<p>CARNEGIE FORUM 305 WEST PINE STREET LODI, CALIFORNIA</p>	<p>AGENDA LODI SITE PLAN & ARCHITECTURAL REVIEW COMMITTEE</p>	<p><u>SPECIAL SESSION</u> MONDAY, OCTOBER 6, 2008 @ 5:15 PM</p>
---	--	--

To: Site Plan and Architectural Review Committee
From: Immanuel Bereket, Assistant Planner, Community Development Department
Date: October 6, 2008
Subject: Request for Site Plan and Architectural Review Committee approval to construct a Café and Deli Building at 730 South Cherokee Lane. (Applicant, Aster Kanet; File # 08-SP-05).

To: Site Plan and Architectural Review Committee
From: Immanuel Bereket, Assistant Planner, Community Development Department
Date: October 6, 2008
Subject: Review a proposed chapel addition to the First Baptist Church of Lodi, located at 267 North Mills Avenue. (Applicant, Larry Wenell; File # 08-SP-07).

Site Plan

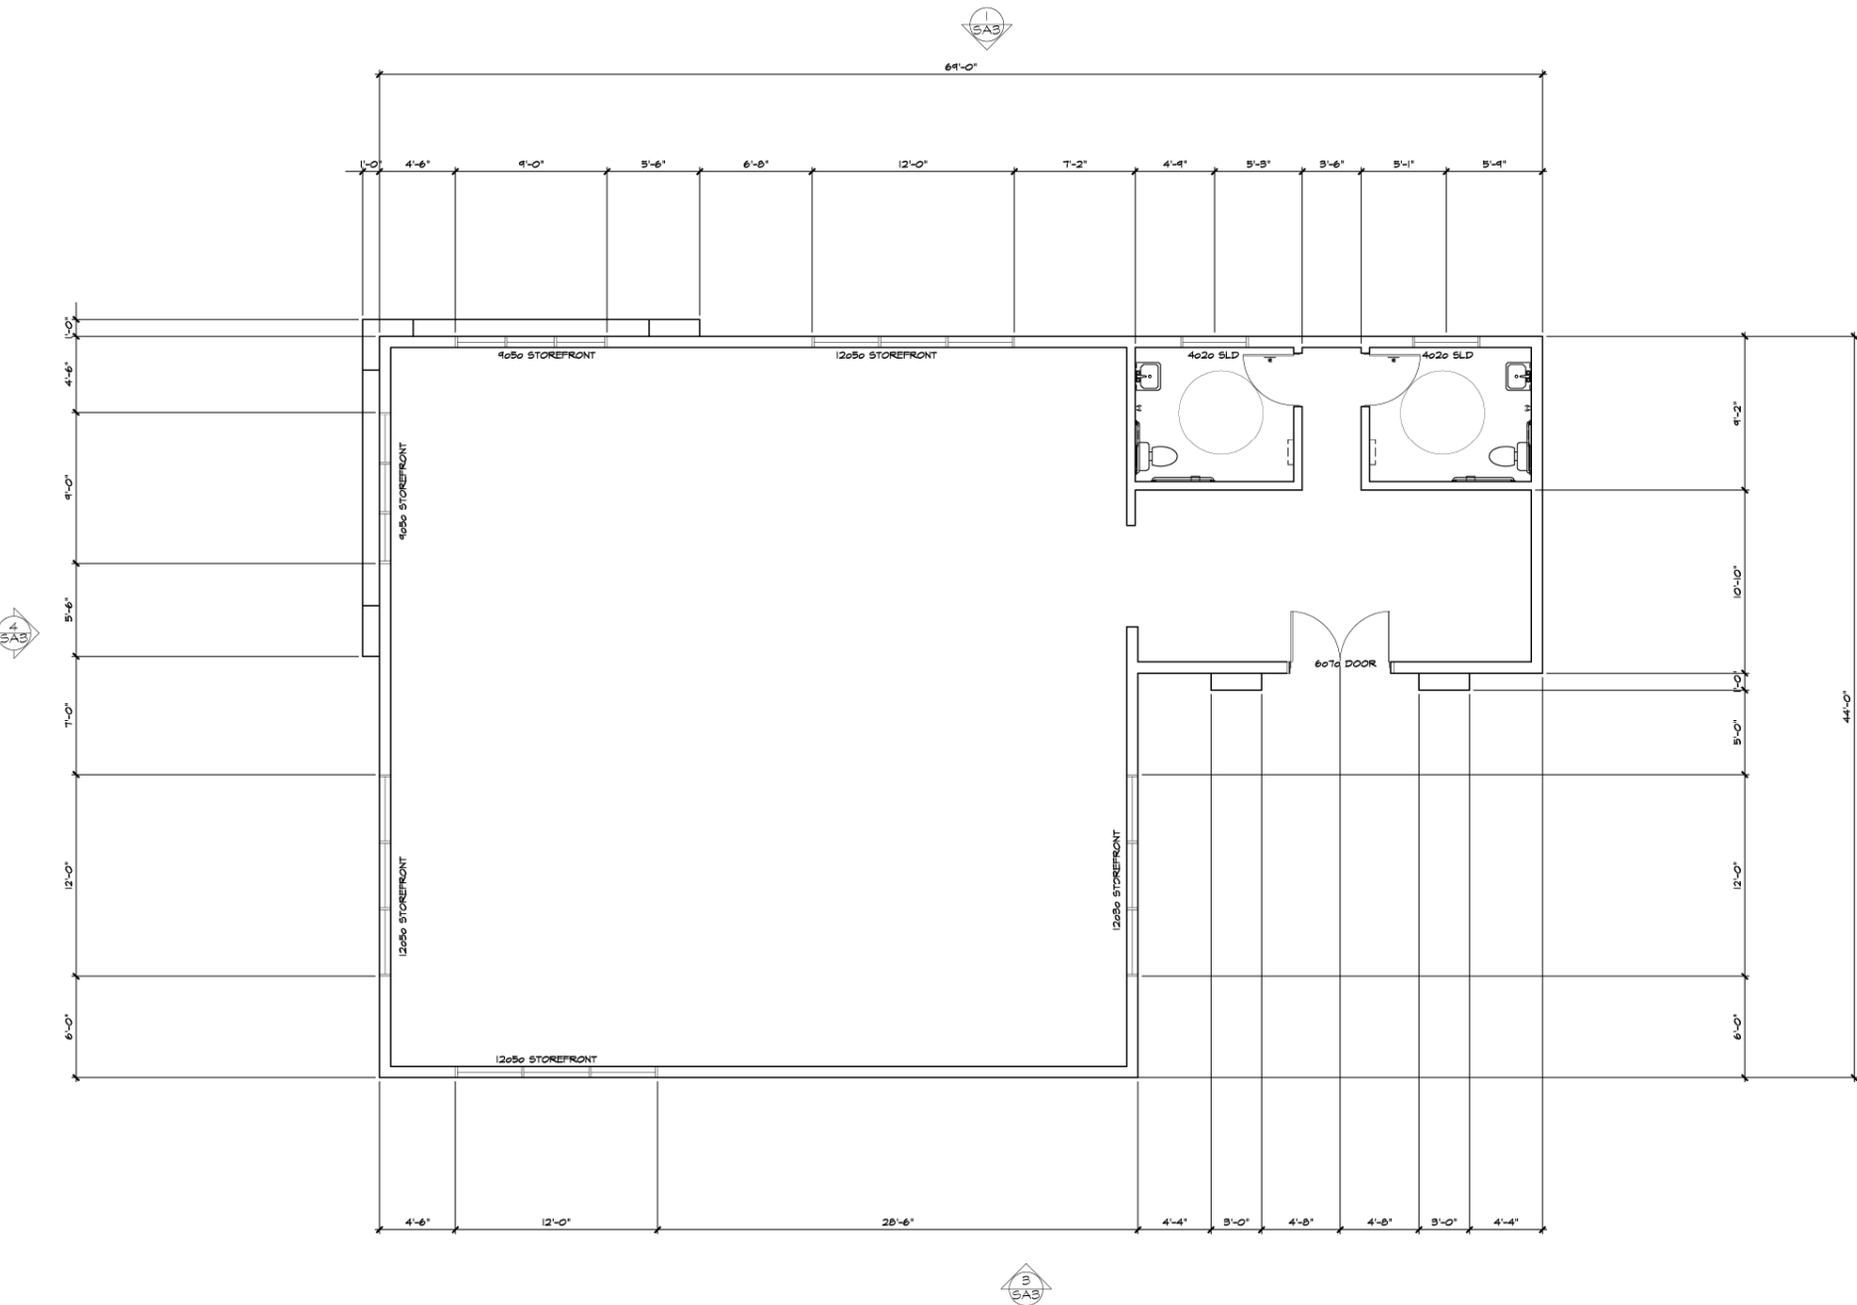
14. The proposed garbage enclosure encroaches onto the existing 10-foot public utility easement (PUE) along the east property line of the project site. The PUE contains an 8-inch public water main. No encroachment onto the PUE shall be allowed. All structures shall be relocated outside the PUE. In addition, no large trees may be planted in the PUE.

17. The proposed driveway on Hale Road shall be a commercial driveway conforming to Standard Plan 114.
18. The existing driveway on Cherokee Lane extends into the frontage of the parcel to the south and is not shown correctly on the site plan. The existing driveway shall be removed and

replaced with curb, gutter and sidewalk to match existing and a new commercial driveway conforming to Standard Plan 111.

Proposed Landscape Plan

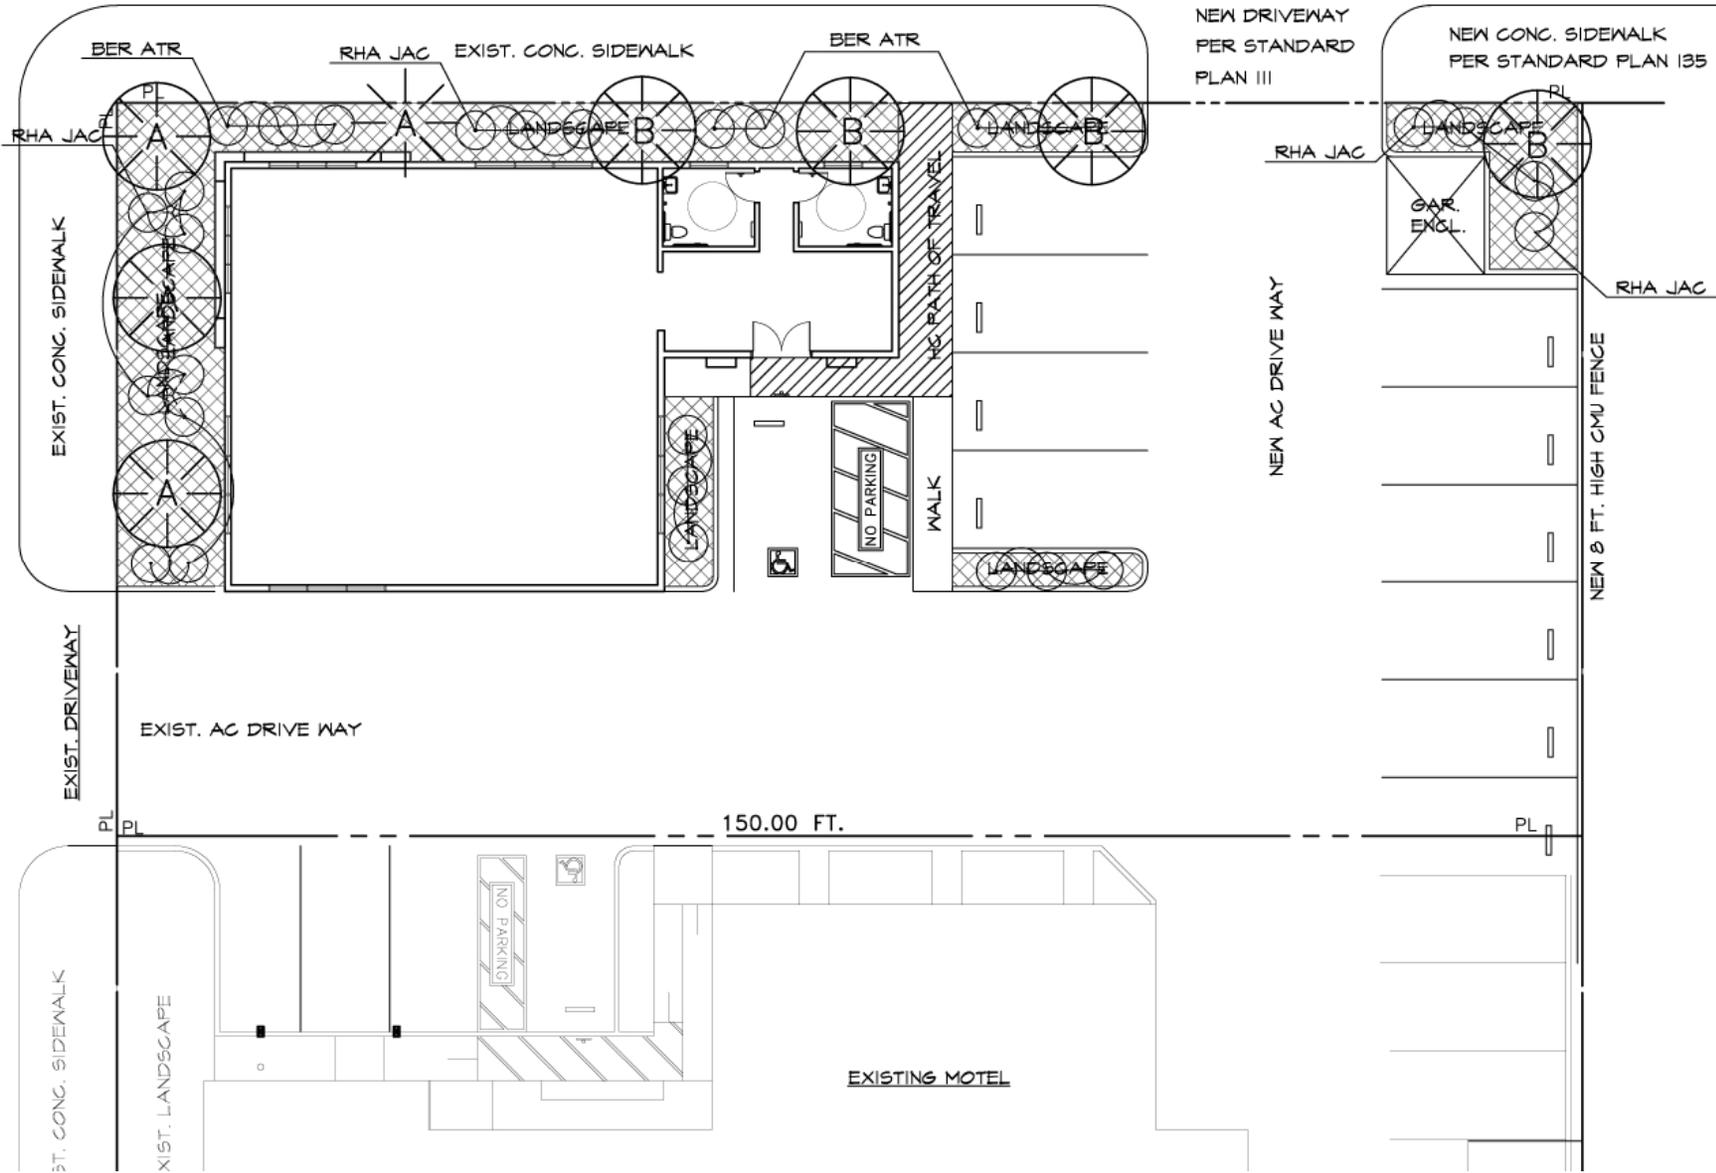
The applicant has proposed a landscaping plan showing landscaping adjacent to the proposed building on Cherokee Lane, as well as adjacent to the building along Hale Road. There is also landscaping adjacent to the proposed garbage enclosure. The proposed landscape plan calls for four 15-gal Crape Myrtle trees, four 15-gal Chinese Pistachio trees and various shrubs and ground cover. It would also be beneficial for the overall appearance of the project if the applicant were to add a trellis above the trash enclosure to screen the enclosure. Because there are residences adjacent to the project site, staff is recommending that placing a trellis above the trash enclosure is appropriate.

Site Plan

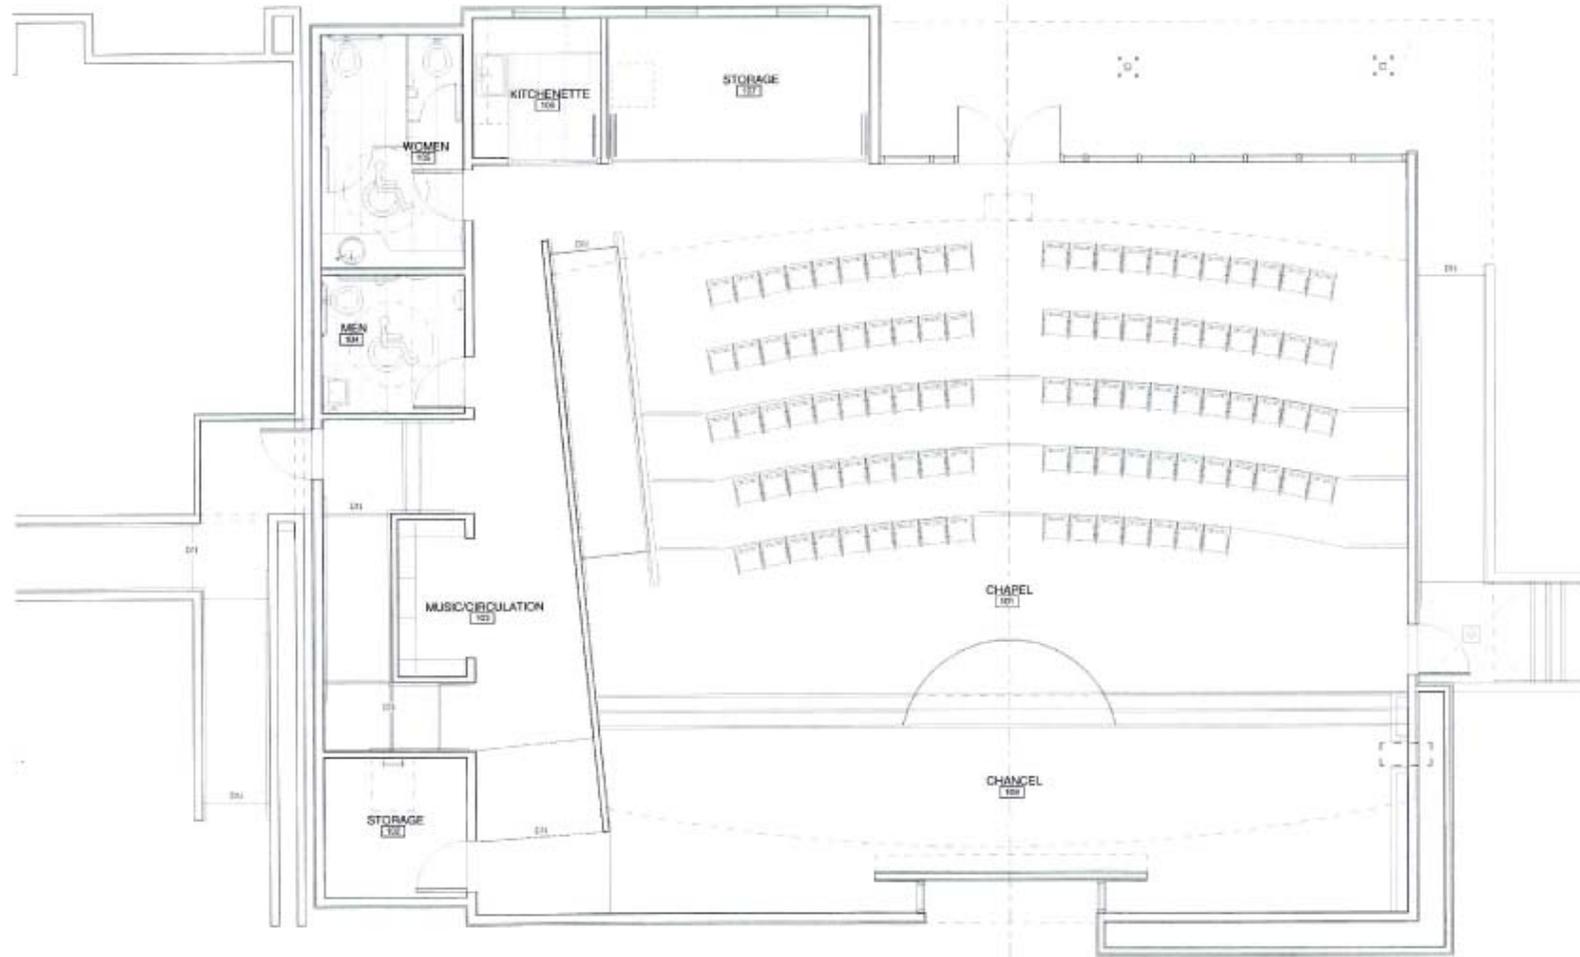
13. The proposed building shown on the plan is located over an existing 6-inch wastewater service for the existing structures on the site. These utilities will have to be relocated outside the footprint of the building.

10. The proposed additional shall not encroach into the existing PUE.
11. The applicant shall pay the Electric Utility Department charges in accordance with the Electric Department's rules and regulations.
12. Additional comments and conditions will be provided when more complete plans are submitted for building permit application review for the project.
